Re: Acadia Cortlandt Crossing, LLC ("Acadia")
Proposed Cortlandt Crossing Retail Development
PB No. 14-13

On behalf of Acadia Cortlandt Crossing, LLC (the "Applicant") we are pleased to submit a response to AKRF's comments on the conceptual landscape plan as well as renderings depicting the architecture and the materials proposed for the Cortlandt Crossing development as requested by the Planning Board at their meetings on August 4, 2015 and September 1, 2015. These materials are being submitted in support of the pending Site Plan application. The updated plans and renderings included herewith were modified in response to comments from the Planning Board, and discussions with Town staff. The revisions include: (i) a modified landscaping plan with respect to the plantings on the berm, (ii) updated site geometry plan that provides a path connecting the pedestrian bridge to the proposed picnic bench area and the retail building sidewalk, and (iii) rendered views of the proposed development from vantage points along Cortlandt Boulevard and from within the retail area.

Re: Proposed Driving Range and Private Teaching Facility
Hudson National Golf Club
Section 67.08, Block 1, Lot 31, To

FIGURE NO. 1

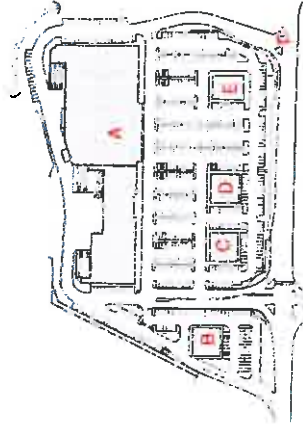
Response: A tiered retaining wall has been incorporated into the site plan, within the area proximate to Cortlandt Boulevard, in order to maintain a 2:1 slope as shown on Sheet SP-4.5.
4. **Comment:** *Guide rails are called out on Sheet SP-1.1 as 'wood guide rail' and 'bumper guard' in two different locations. Will these rails have a similar appearance to one another?*

Response: Only wood bumper guards will be utilized within the parking areas, as shown on the revised Sheet SP-1.1, *Site Geometry Plan*. A detail of the

wood bumper guard is provided on Figure 1, attached to this letter.

ALT. MOVE TEE BOX

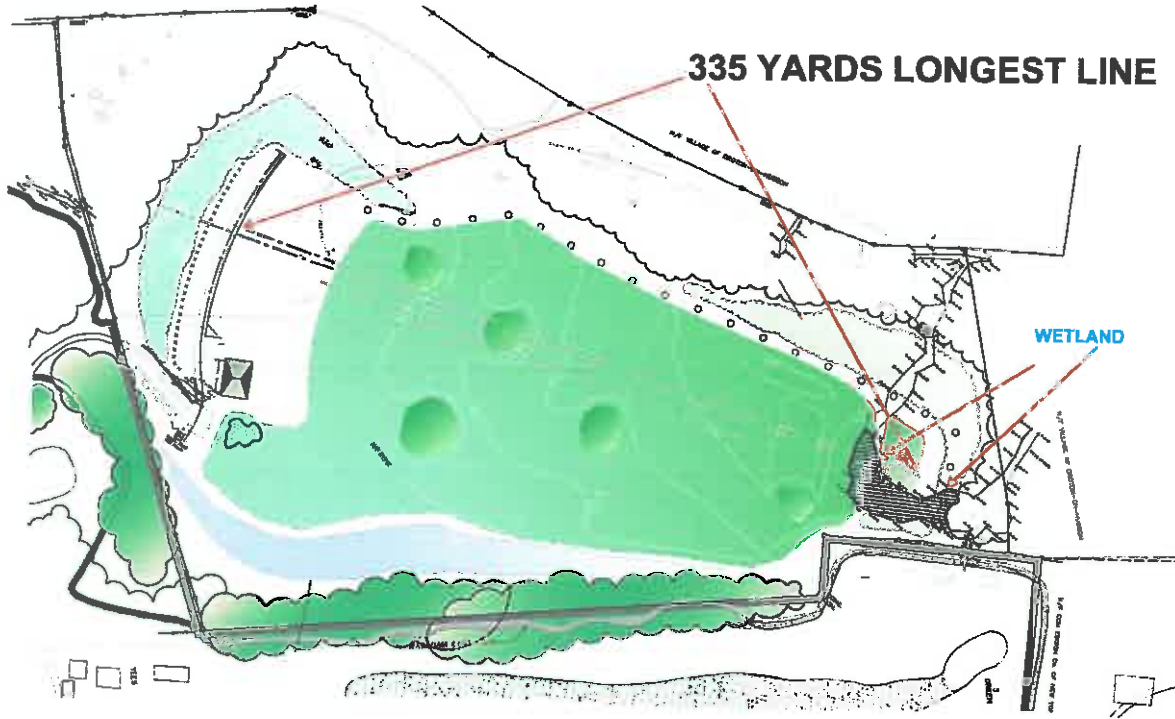
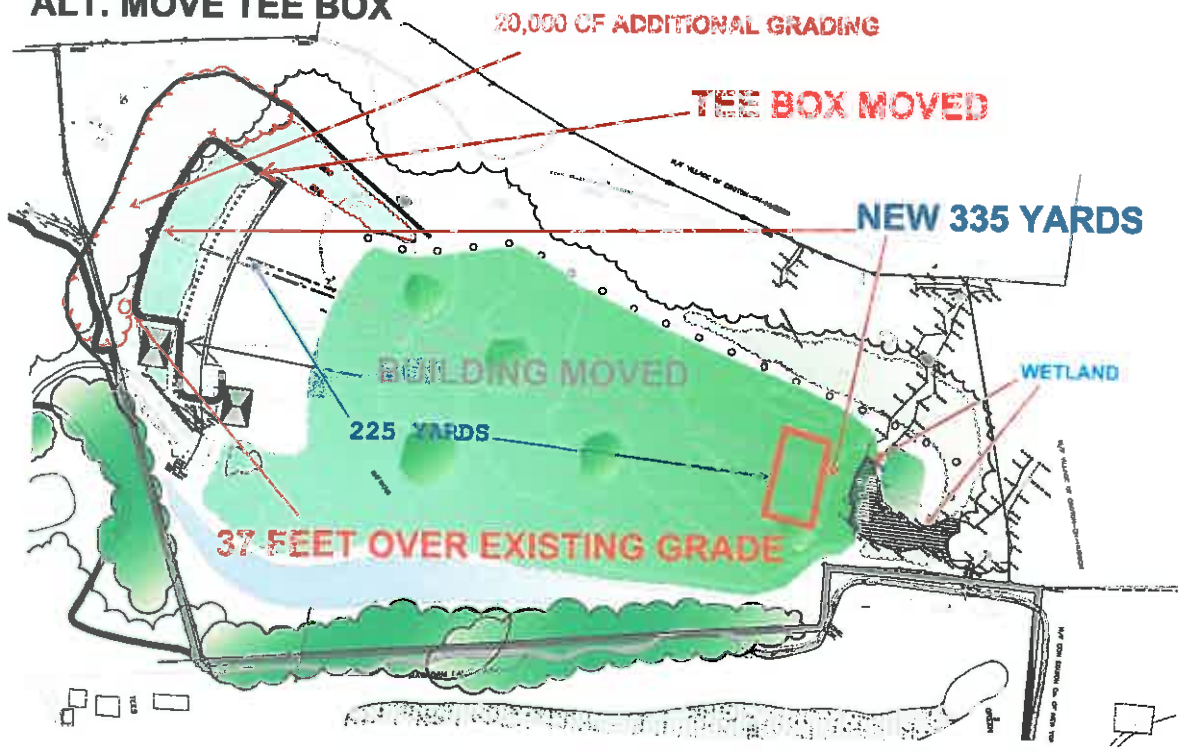
Comment: I believe a more suitable alternative would be max out your range by shifting the tee areas southwest and eliminating the northern tee box altogether and just grade it out more subtly (3:1). You can still get your 300+ yard range, utilize all clubs and have the existing range area for overflow (i.e. one tee area to distance you can reasonably achieve with the grading you show).

We have tried your suggestion to move the main tee box to the southwest, however, this would create substantial new problems that would be difficult for the Planning Board to accept. Here are just a few of the problems:

1. The move would increase the steep slope disturbance, unfortunately, in an area that we would have less control over since it would be at the extrema of the site and erosion could affect other properties. In the current plan we have kept a significant buffer from the property line to allow us to employ proper erosion control measures.
2. In viewing a profile of the range, substantially more fill needs to be imported to make up for the steep drop at the south west. A simple estimate of the additional fill required is on the order of 20,000 cubic yards that will have to be trucked in to the site.

In the current plan the cut and fill balances – no mass fill needs to be imported.

Alternatively, a move to the south west may require a 30 to 40 plus foot retaining wall (475 ft. to 517 ft. elevs.) to keep the grade of the main tee box. In the current plan there are no walls and the site is designed to look natural in the surroundings.

3. We are also mindful that moving the main tee box to the south west would eliminate the vegetated buffer at the nature preserve and would shrink the proposed conservation easement. The current plan provides a significant green buffer as well as a conservation easement.

4. Importantly, if we moved the tee box to the south west the construction would be much closer to a flagged wetland, a small stream and a specimen 50" white oak tree. The current plan respects these features to a much greater extent.
5. The movement to the south west would present construction problems since the slope in that area is about 20%. It would be a challenge to develop such a large, stable constructed slope upon that already steep slope.
